Intel® Server Board S2600WF Product Family
Intel® Server Board S2600BP Product Family
Intel® Server Board S2600ST Product Family

Specification Update

Q3 2022

PMBus Connections

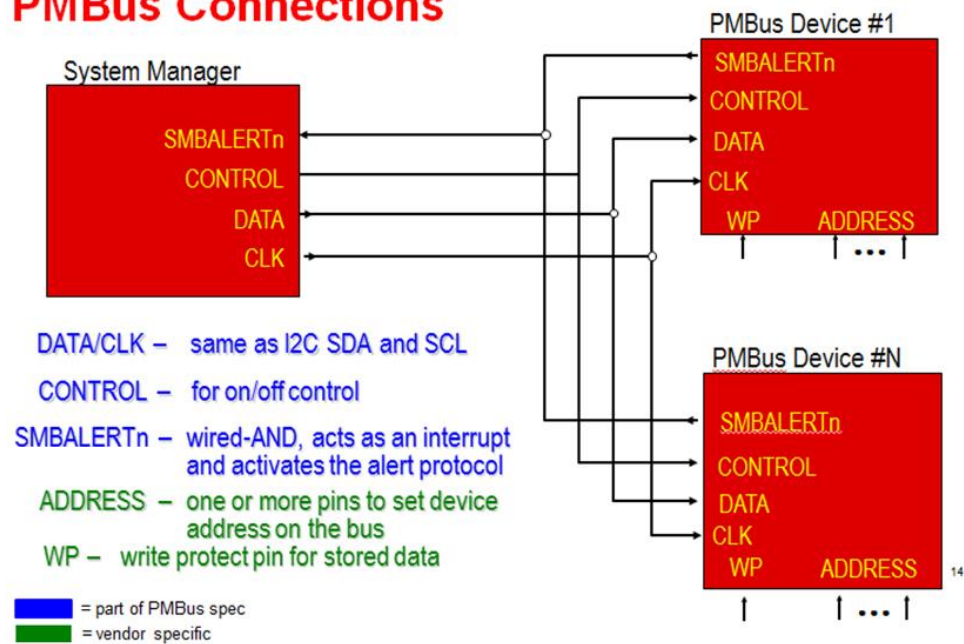
Problem Customer may see the following event in the SEL:

This event means that SMLink1 is temporarily unavailable. If there are not SMART/CLST events recorded in the SEL, this is considered a warning, no function is impacted by it and no action needs to be taken.

The root cause is that, in a multi-main PMBus* environment, if a client device holds a Serial Clock Line (SCL) low for too long (exceed `TTIMEOUT`, defined in PMBus* 1.2 specifications), the Intel® ME will detect the symptom and assert the health event.

Workaround None.
